Economic Commission for Europe**Administrative Committee for the TIR Convention, 1975****Technical Implementation Body****Fourth session**

eTIR conceptual, functional and technical specifications:**Version 4.4****Concrete amendment proposals*****Note by the secretariat****I. Background and mandate**

Current customs management of guarantees class diagram

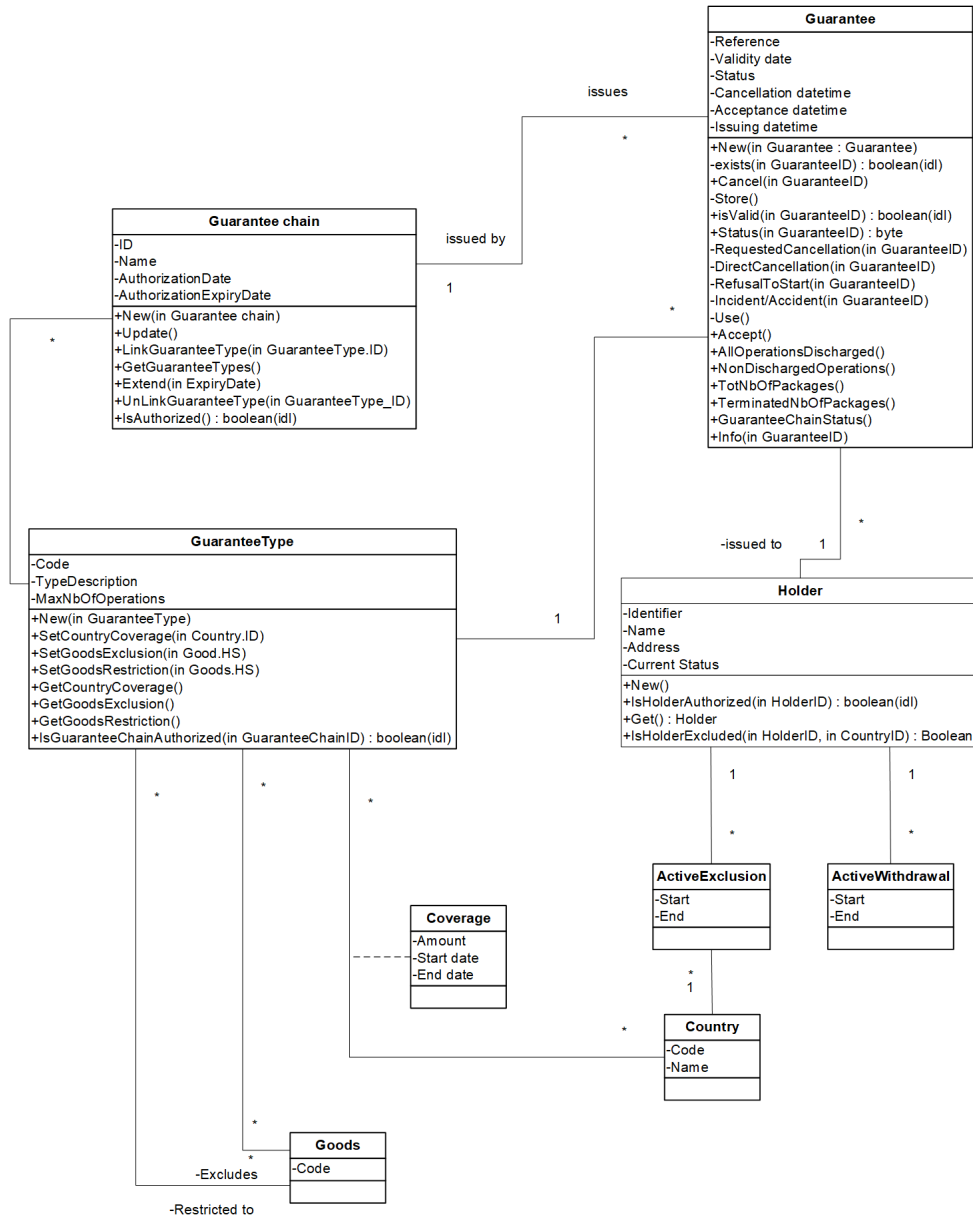
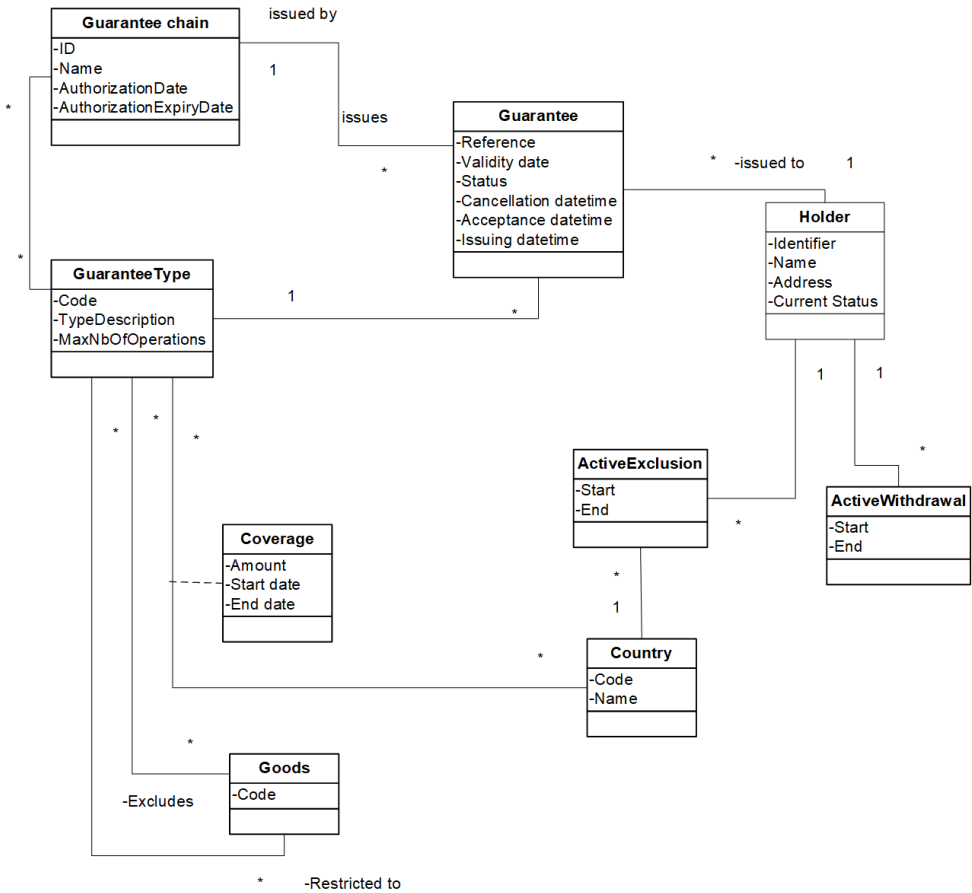
23. UML Class diagrams used in version 4.3 of the eTIR functional specifications contain not only classes, their relationships and their attributes, but also a set of methods that were aimed at facilitating the development of the eTIR international system. As such, these methods have little to no use for the countries that wish to amend their customs system to implement the eTIR procedure. Figures I and II below show the difference between the current and the simplified version of the customs management of guarantees class diagram (Figure 1.19 of the eTIR functional specifications).

24. At its third session, TIB agreed to simplify the class diagrams.

Figure V
Business Process Diagram for the Start TIR operation process

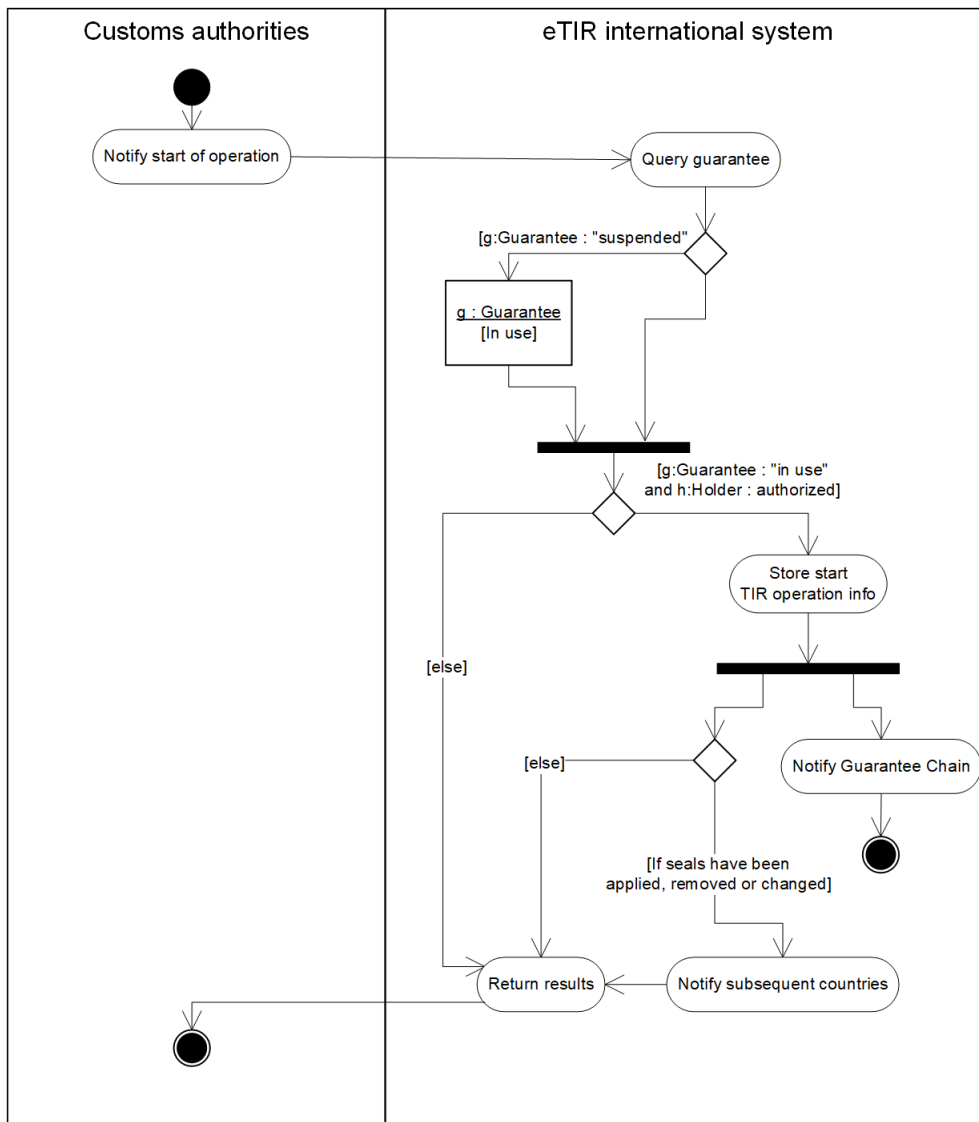
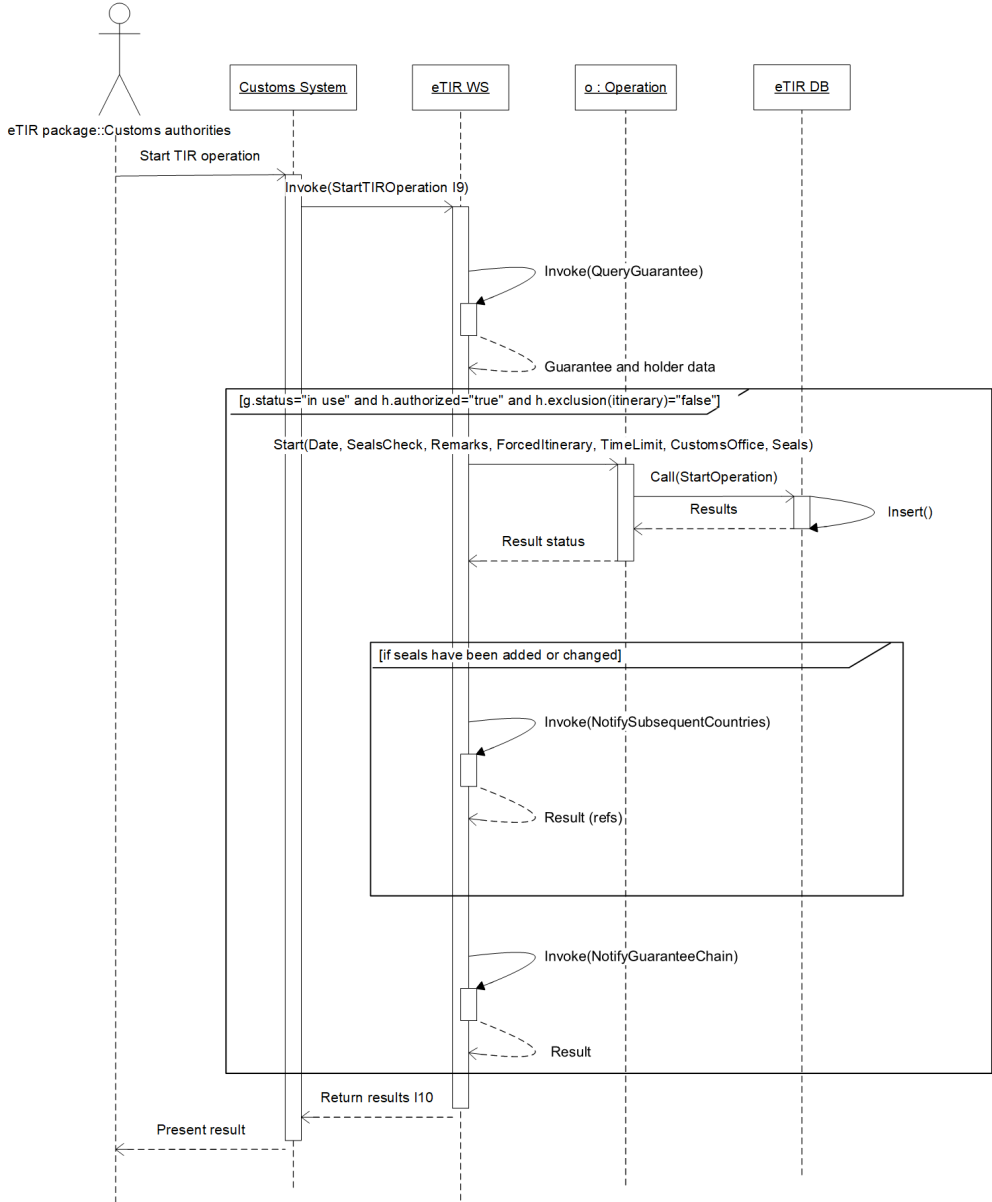
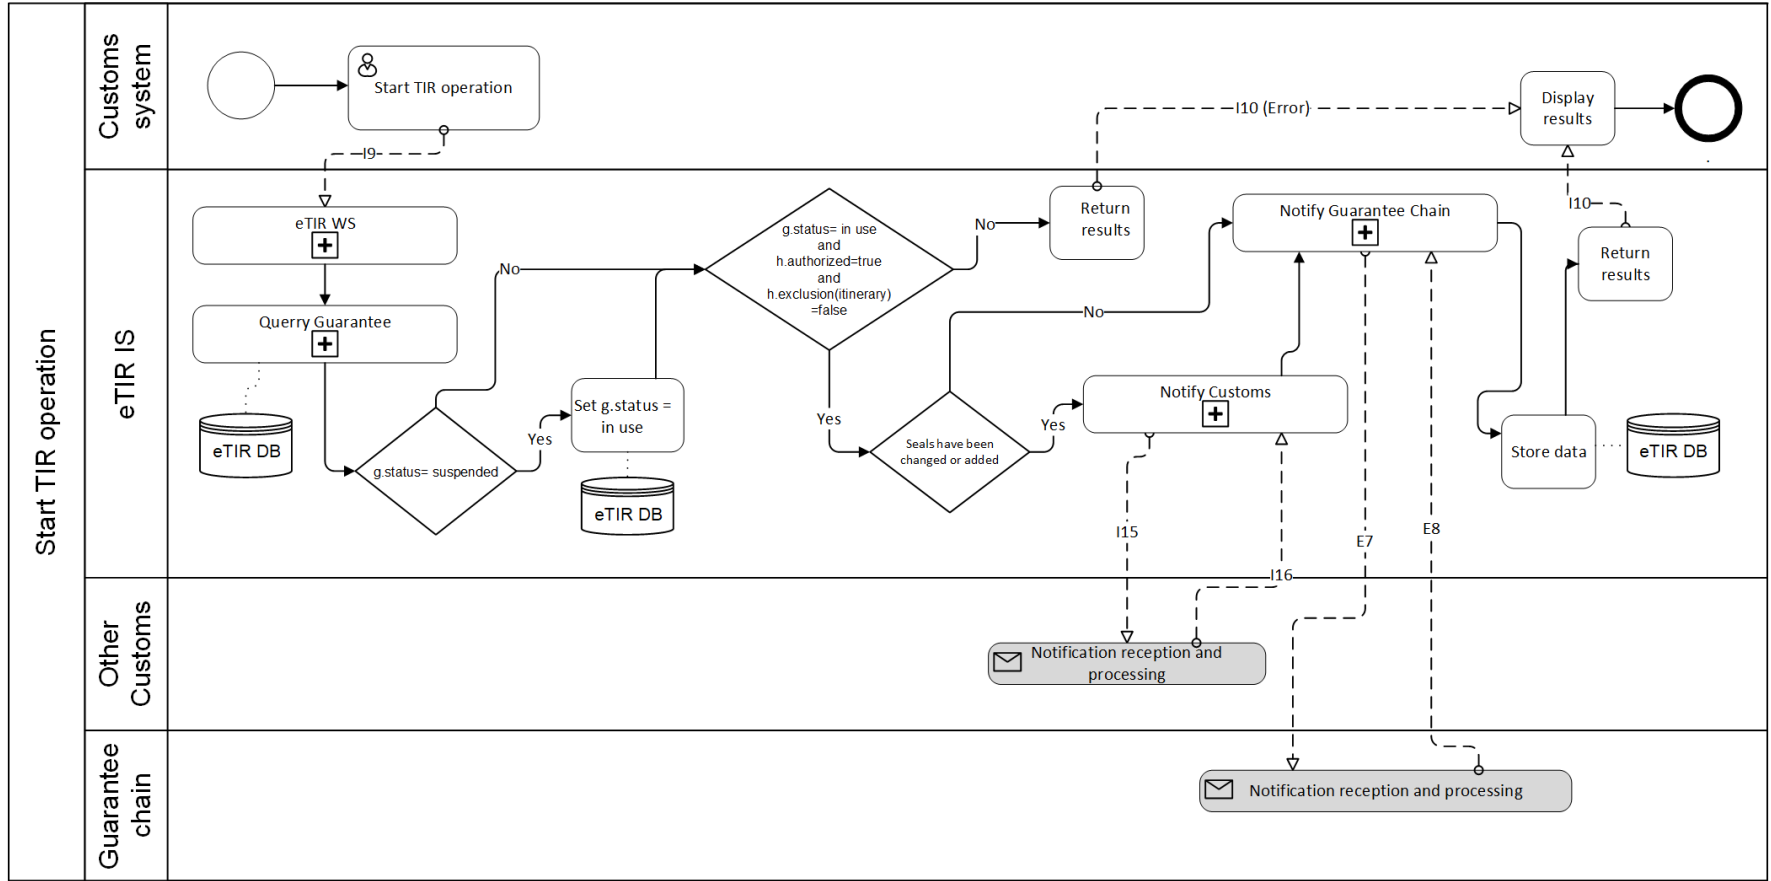
25. In version 4.3 of the eTIR specifications, in line with the Unified Modelling Methodology (UML) chosen originally for the eTIR project, the modelling of processes is done using UML activity and sequence diagrams. In recent years, the business process model and notation (BPMN) has gained in popularity in both the business and Information and Communication Technologies (ICT) communities and is, therefore, better understood by laymen and experts alike. With that in mind, TIB might wish to consider if, in version 4.4 of the eTIR specifications, BPMN should replace the activity and sequence diagrams used in version 4.3. Figures III, IV and V below show the UML activity diagram (Figure 12 of the eTIR concepts), UML sequence diagram (Figure 1.9 of the eTIR functional specifications) and the Business Process Diagram for the Start TIR operation process.

26. At its third session, TIB agreed to replace the existing diagrams (in Unified Modelling Methodology – UML) in the conceptual and functional specifications with the newly proposed diagrams (in Business Process Model and Notation – BPMN), in line with the examples above.
